SAFETY EVALUATION BY THE OFFICE OF NUCLEAR REACTOR REGULATION
SUPPORTING AMENDMENT NO. 34 TO FACILITY OPERATING LICENSE NO. DPR-68

BROWNS FERRY NUCLEAR PLANT, UNIT NO. 3

DOCKET NO. 50-296

Residual Heat Removal System, Unit
Cross Connections and Standby Coolant Supply

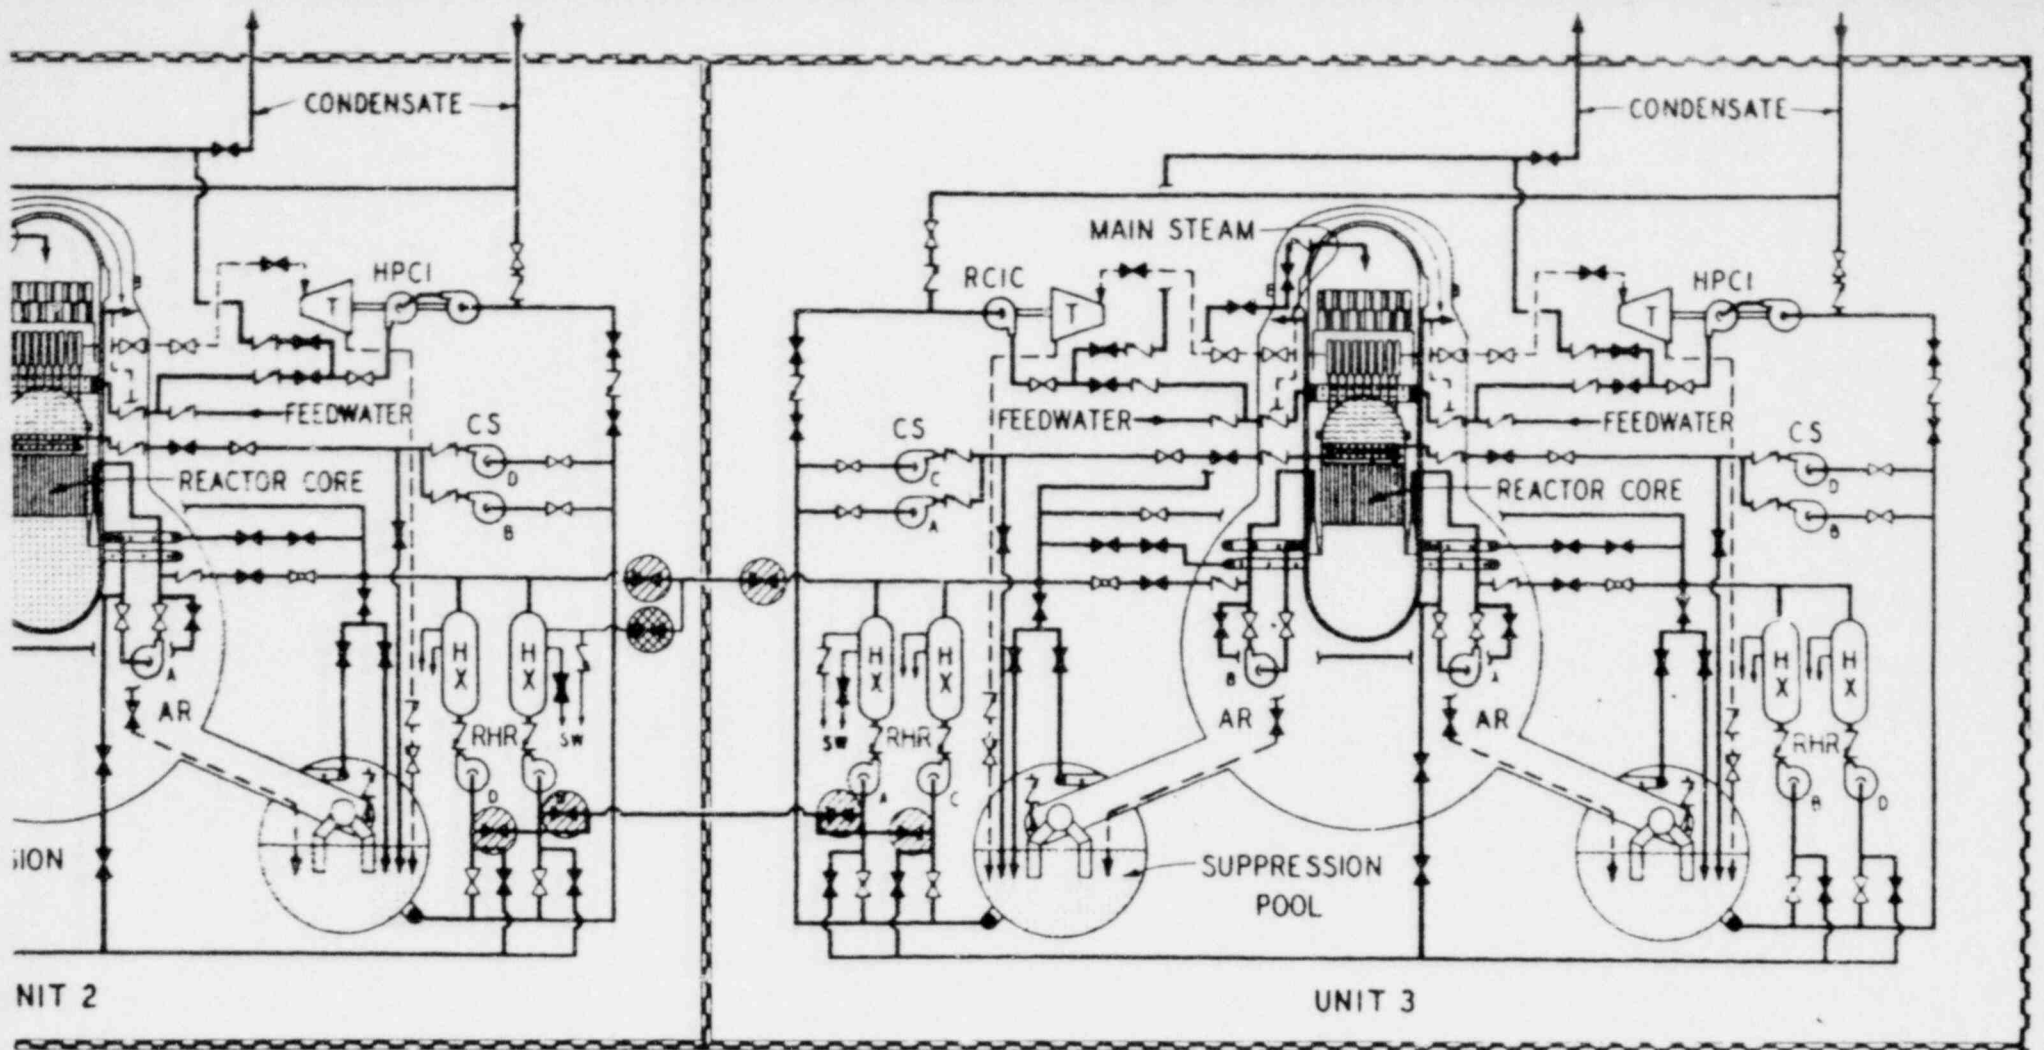
Each of the three Browns Ferry units has four residual heat removal (RHR) heat exchangers and four associated main system pumps. One of the RHR loops, consisting of two heat exchangers, two main system pumps in parallel, and associated piping, is located in one area of the reactor building. The other heat exchangers, pumps, and piping, forming a second loop, are located in another area of the reactor building to minimize the possibility of a single physical event causing the loss of the entire system. In addition, the pump suction and heat exchanger discharge lines of one loop in Unit 1 are cross-connected to the pump suction and heat exchanger discharge lines of one loop in Unit 2. Unit 2 and Unit 3 systems are cross-connected in a similar manner. Two normally closed isolation valves are provided in each heat exchanger discharge cross-connection and four normally closed isolation valves are provided in each suction cross-connection (one at each pump suction). This arrangement between Units 2 and 3 is shown in the attached figure; the cross-connection valves are those in the cross-hatched circles.

exchangers in each unit is adequate for all required functions. The cross-connections between the units in the RHR systems thus provide a third, redundant backup cooling system in case the pumps and heat exchangers in an RHR loop of an adjoining unit are both inoperable. As can be noted in the attached figure, the RHR heat exchangers and their associated pumps are in parallel with each other, so that a heat exchanger can be used even if the other heat exchanger in the loop is out of operation.

There is one other backup crosstie connection pertinent to this evaluation. On the service water outlet from the 1D RHR heat exchanger in Unit 1 and on the service water outlet from the 2B RHR heat exchanger in Unit 2, there is a connection to the primary system crosstie between the units. The connection from the 2B heat exchanger is shown in the attached figure. If all primary coolant and suppression pool water and condensate were lost, this cross-connection would permit the pair of B service water pumps to supply raw river water to the reactor core of Unit 2 or 3 (after the pressure approaches 50 psig) or to supply river water to the respective suppression chambers. Thus, the RHR service water in the B loop in Unit 2 is an emergency back-up supply of cooling water to Unit 3. Because of this function, the present Technical Specifications for Unit No. 3 only permit the unit to be operated for 30 days if one of the B1 or B2 RHRSW pumps is inoperable and require shutdown of the unit if the service water to the Unit No. 2 2B RHR heat exchanger is lost. TVA has requested that the present Technical Specifications for Unit No. 3 be amended to permit Unit No. 3 to be

To perform the required heat exchanger maintenance, both the RHR and RHRSW lines must be isolated. Isolation of the RHRSW line to the 2B heat exchanger isolates the standby coolant supply (RHRSW supply) from Unit 2 to Unit 3. Technical Specification 3.5.C.3 (Unit 3) presently states that "During power operation, both RHRSW pumps B1 and B2 normally or alternately assigned to the RHR heat exchanger header supplying the standby coolant supply connection must be operable." Although the proposed maintenance activity will not affect the operability of the 1B and 2B RHRSW pumps, it will isolate the RHR heat exchanger header supplying the standby coolant supply connection.

Although the present Technical Specifications as noted above permit operation for up to 10 days without the RHR primary coolant cross-flow capability, as described in the above "Discussion", Section 3.5.C.3 does not permit operation without the RHR service water cross-flow capability. The probability of needing-or using-the raw river water for backup cooling capability is far less than the possibility of using the RHR cross flow capability. If the raw service water were needed for backup coolant supply in Unit No. 3, the normal source would be the service water headers in Unit No. 3, rather than the cross-connection from Unit No. 2. If the RHR cross-flow connection can be out of service for 10 days - and our reevaluation concludes that this is reasonable and acceptable - it is logical and acceptable that the service water cross-connection can be out of service for 10 days also in view of the very low probability of ever needing this redundant backup source of raw river cooling water. We conclude that the proposed Technical Specification change to allow a 10 day outage time for the RHRSW cross-flow connection between units is acceptable and that the overall reduction in plant safety margin is insignificant.
